JOINT REGIONAL PLANNING PANEL - SOUTHERN REGION COUNCIL ASSESSMENT REPORT

Panel Reference	2017STH029
DA Number	RA17/1002
Local Government Area	Shoalhaven City Council
Proposed Development	Construction of a residential apartment complex consisting of two buildings containing: four (4) x studios; 16 x one-bedroom; 45 x two-bedroom and 26 x three-bedroom apartments. Total – 91 apartments. A basement car parking area with 140 spaces
Street Address	204, 206 and 208 Kinghorne Street, Nowra - Lot 1 DP 130928, Lot A DP 370205 and Lot 5 DP 542693 19 and 21 Gould Avenue, Nowra - Lot A DP 392035 & Lot B DP 370205
Applicant/Owner	Planning Development Commercial Lawyers Pty Ltd T/as PDC Services as Agents for Tonandua Pty Ltd
Date of Lodgement	1 November 2017
Owner	TONANDUA PTY LTD
Number of Submissions	Nil (0)
Recommendations	Refusal in accordance with the reasons for refusal contained in Section 8 of this Report.
Regional Development Criteria (Schedule 4A of the Act)	At the time of lodgement Schedule 4A of the <i>Environmental Planning and Assessment Act 1979</i> (EPA Act) was operative. The proposed development satisfies clause 3 of Schedule 4A, being a development that has a capital invest

Figure 14 - Extract from the SLEP 2014 Height of Building Map. Subject site highlighted. **Note:** I2 = 8.5m and N2 = 14m.

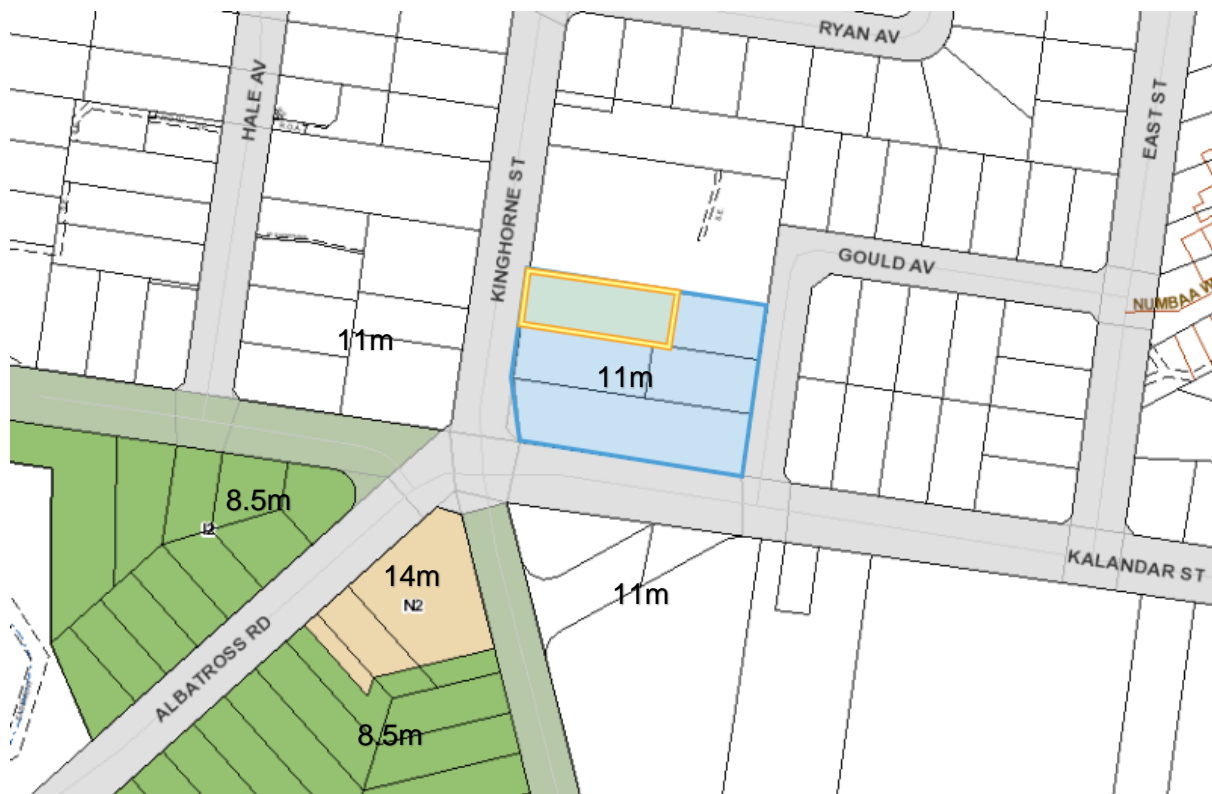
The Height of Buildings Map does not show a maximum height for the land (subclause 2A)), and therefore the height of a building on the land is not to exceed 11 metres. An extract from the Height of Building Map is provided in **Figure 14** below.

The development proposed exceeds the 11m height limit. The application seeks a variation to clause 4.3 in accordance with clause 4.6 of SLEP 2014.

The entire roof exceeds the height limit. There are 4 lift over runs that also penetrate the height plane and a portion of the building that exceeds the height by 2.32m (maximum) in the south eastern corner. This is illustrated in **Figure 14** below.

Figure 22 - Roof plan indicating individual points on the roof where the development exceeds the maximum height of buildings development standard. the roof plan relates to the Table 2 below which provides the height exceedance calculations for the individual points identified in the roof plan.

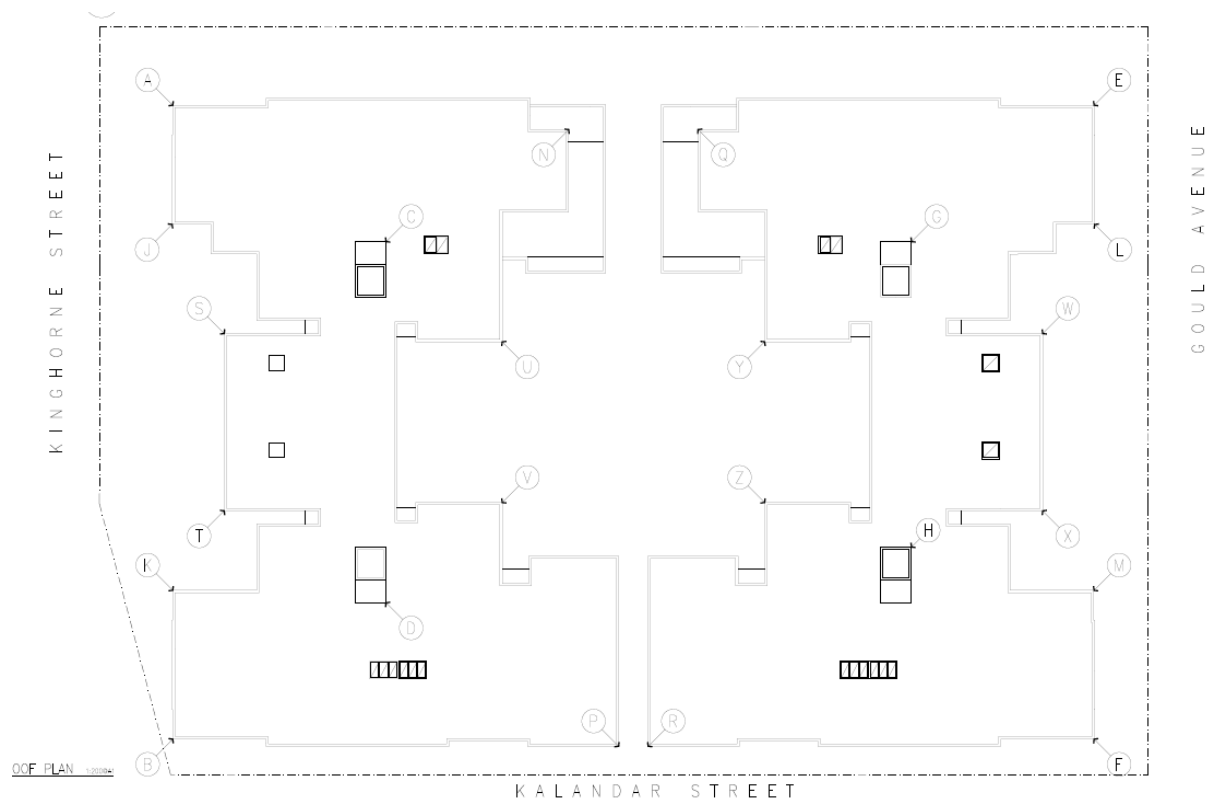
The largest exceedance of the maximum building height occurs along a portion of the eastern elevation to Gould Avenue. The structure has a maximum height of 13.32m at "point L", as identified in **Figure 22 and Table 2**. The extent of the variation to the numerical standard is 2.32m or 21.1% (refer to **Figure 15 - 18**).
